ADDENDUM NO. 8**DATE: 08/24/2023**DARDEN PROJECT NO.
DSA Application Number2180
02-120251**PROJECT:**Mission Oak HS Aquatic Complex
3442 E Bardsley Ave, Tulare, CA 93274
Bid No 2301**OWNER:**Tulare Joint Union High School District
426 N Blackstone St,
Tulare, CA 93274**ARCHITECT:**DARDEN ARCHITECTS, INC.
Attention: Fred Messias
6790 N. West Avenue
Fresno, California 93711
T. (559) 448-8051
F. (559) 446-1765**CONSTRUCTION MANAGER**CM Construction Services
Attention: Chris Hale
P.O. BOX 6237
Visalia, CA 93290
T. (559) 735-9556
M. (669) 804-6685**BID QUESTIONS**NON-MANDATORY JOB WALK
BID QUESTIONS, Submit By
BID OPENING DATE**Chris Hale**chris@cmconstructionservices.com08/08/2023 3:30 PM
08/22/2023 2:00 PM
08/31/2023 Before 2:00 PM

AD8-A01 Refer to Drawing SD/A407- DETAILS - ENCLOSURE DETAILS

SITE DEVELOPMENT
DETAILS - ENCLOSURE DETAILS

SD/A407
AD8-AX01

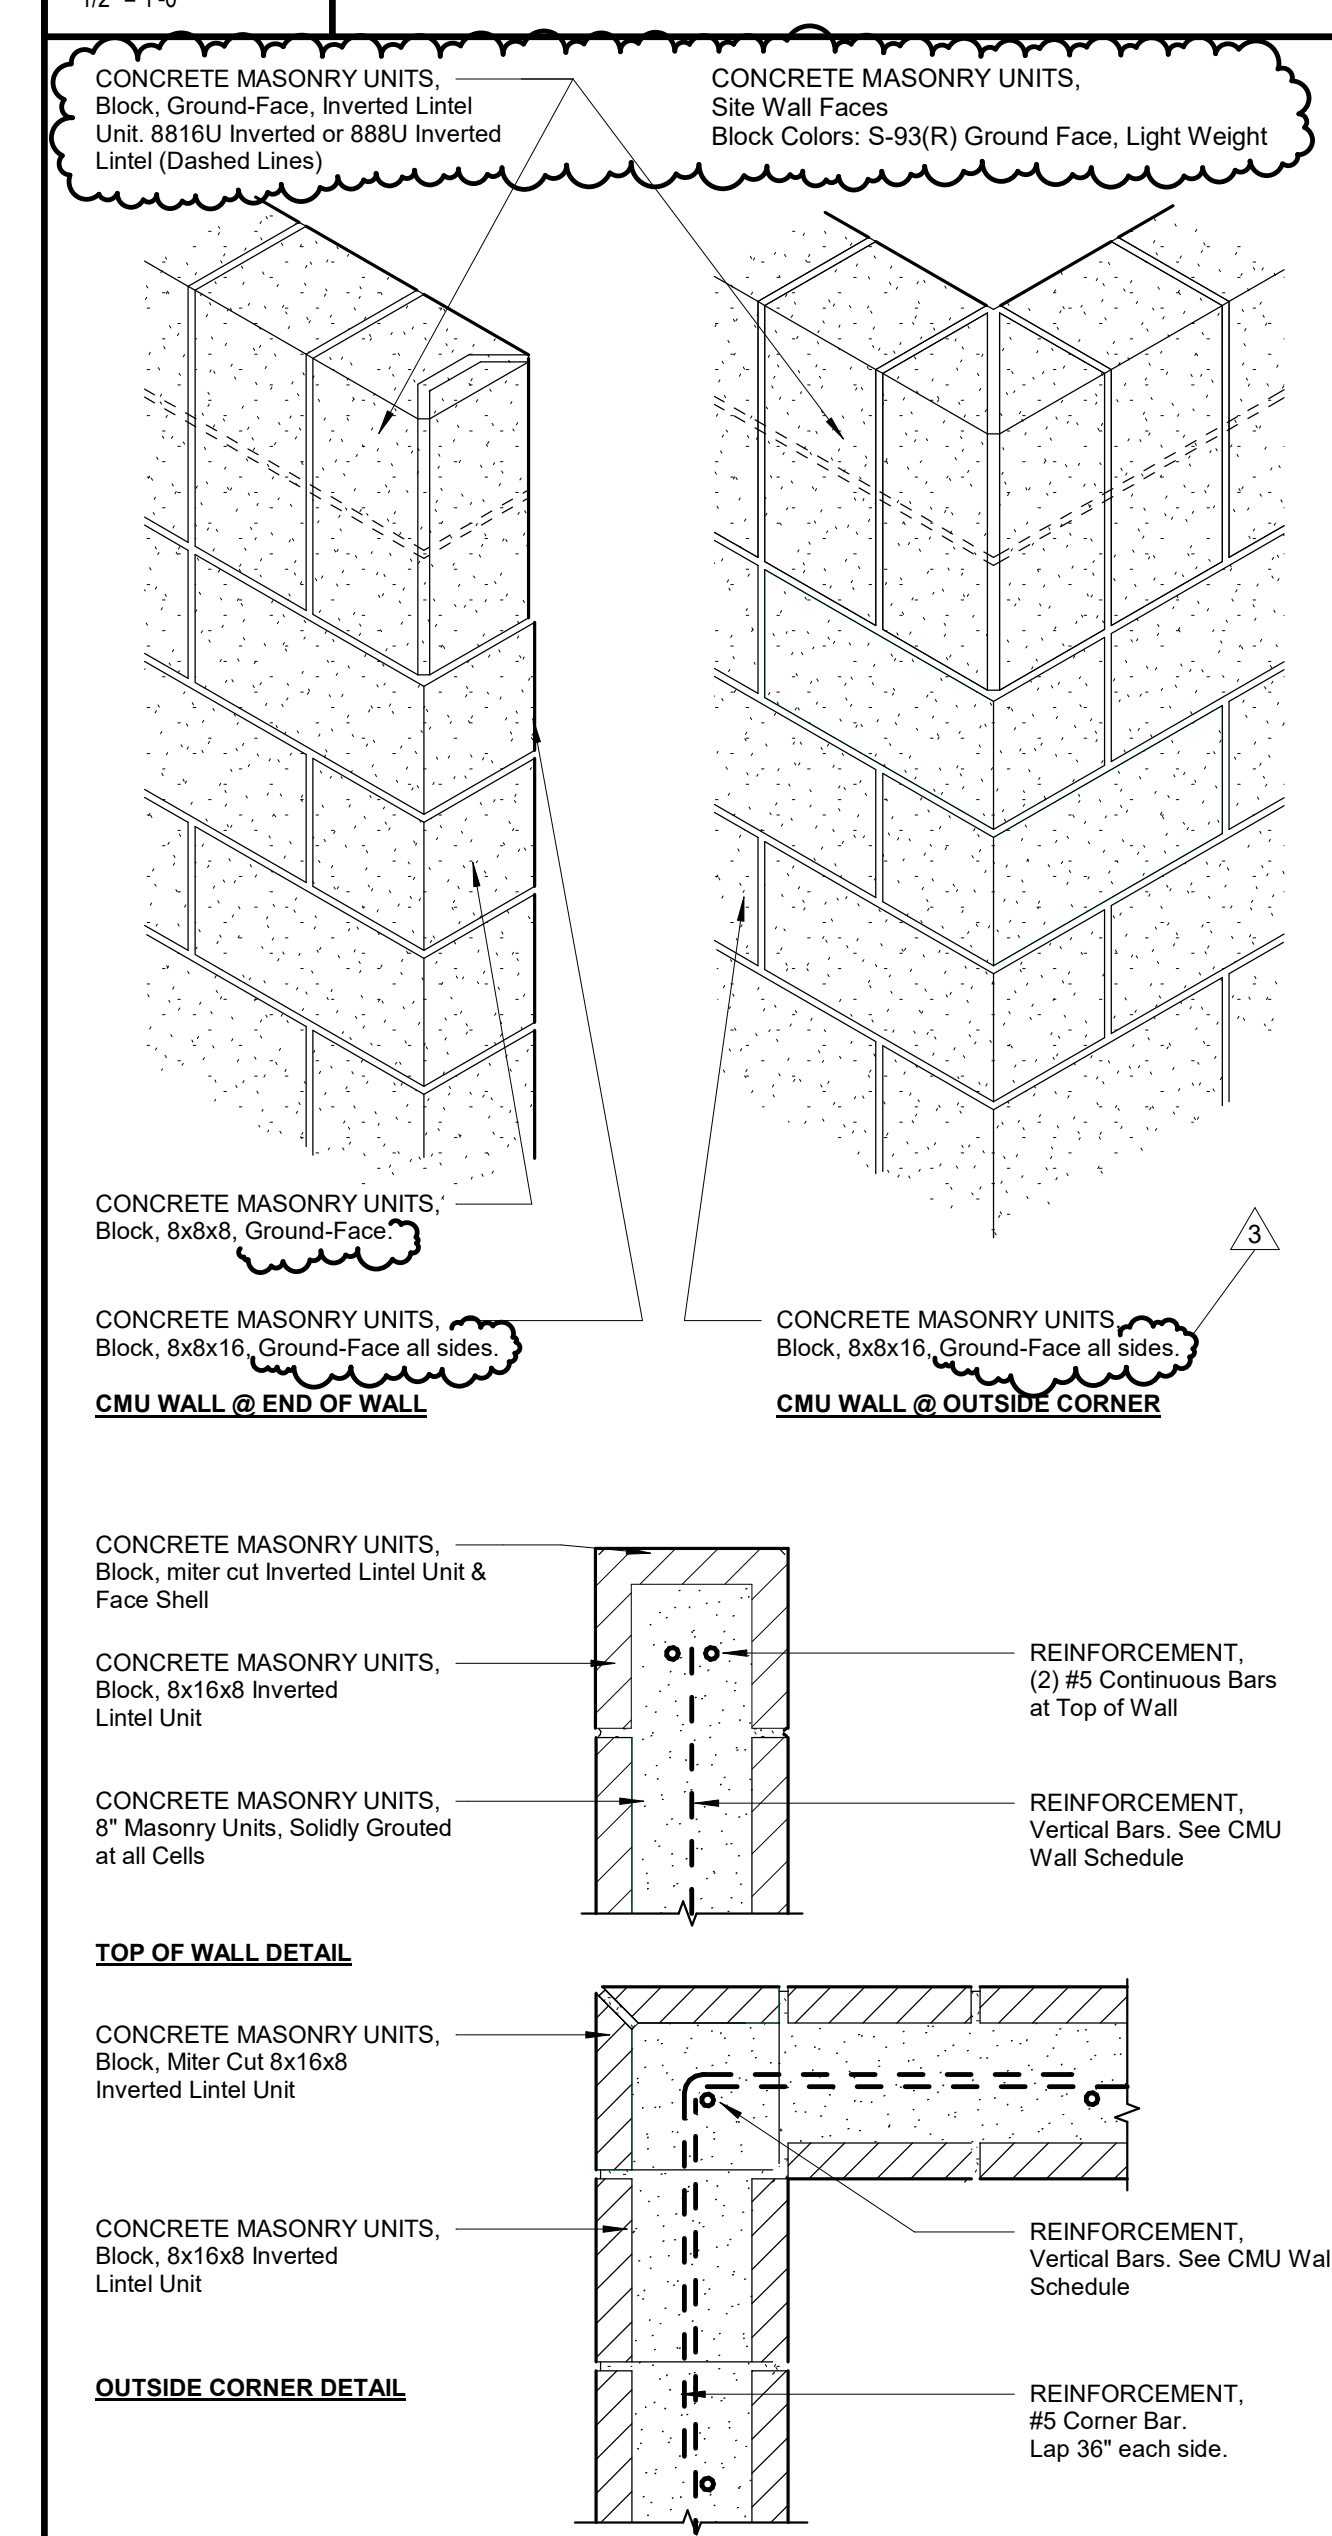
1. This addendum item is responding to a Bid Question.
2. Omit Drawing SD/A407
3. Add Drawing SD/A407 AD8-AX01. The changes to the drawing sheet are clouded.
